Access Compliance Report

Public Rights-of-Way

(Curb Ramps)

Intersection ID: 10029120	Main Street: JAMES_BLAKENEY_AV	Cross Street: N/A	Location: NW
ADA ID: 6208D5AE182A	Ramp Type: PerpDiag	Initial Pass/Fail: Fail	Overall Compliance: No
Severity Score: 13.75			
Codes/Mitigation Info/Possible Solution		Field Measurements/Component Compliance

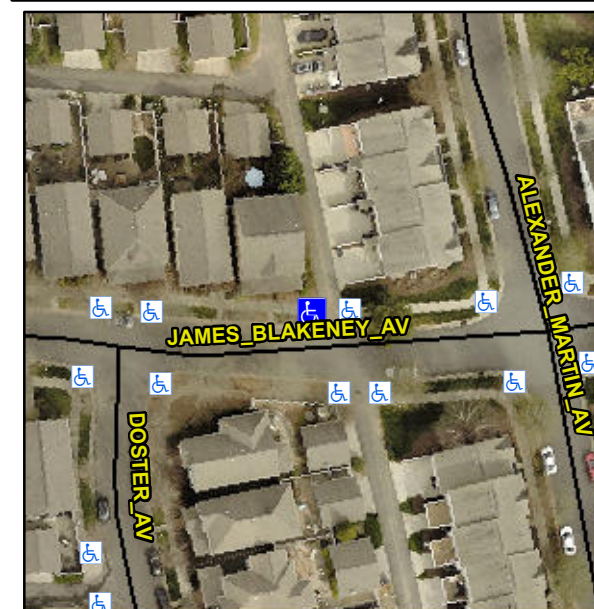
R304.2.2, R304.5.3

Compliance	Description	Data	Compliance	Description	Data
N/A	Ramp Length (in)	82.0	No	Ramp Slope (%)	9.0
Yes	Ramp Width (in)	49.0	No	Ramp XSlope (%)	2.3
N/A	Flare Type LT	N/A	N/A	Flare Type RT	N/A
N/A	Flare Slope LT (%)	N/A	N/A	Flare Slope RT (%)	N/A
N/A	Flare Traversable LT?	N/A	N/A	Flare Traversable RT?	N/A
N/A	Landing Length (in)	N/A	N/A	DWS Provided?	N/A
N/A	Landing Width (in)	N/A	N/A	DWS Contrast?	N/A
N/A	Landing Slope (%)	N/A	N/A	DWS Length (in)	N/A
N/A	Landing X Slope (%)	N/A	N/A	DWS Full Width?	N/A
N/A	Landing Curb? (Y/N)	N/A	N/A	DWS Offset (in)	N/A
N/A	Shared Landing?	N/A			
N/A	Gutter Ponding?	N/A	N/A	Gutter Slope (%)	N/A
N/A	Gutter Lip Ht (in)	N/A	N/A	Gutter X Slope (%)	N/A
N/A	Painted X Walk1?	No	N/A	Painted X Walk2?	No
	X Walk 1 Direction	To S		X Walk 2 Direction	To SE
N/A	X Walk 1 Width (in)	N/A	N/A	X Walk 2 Width (in)	N/A
	X Walk 1 Slope (%)	4.7		X Walk 2 Slope (%)	3.2
	X Walk 1 X Slope (%)	0.9		X Walk 2 X Slope (%)	0.9

Remove & Replace Curb Ramp With Two New Directional Ramps or Equivalent.
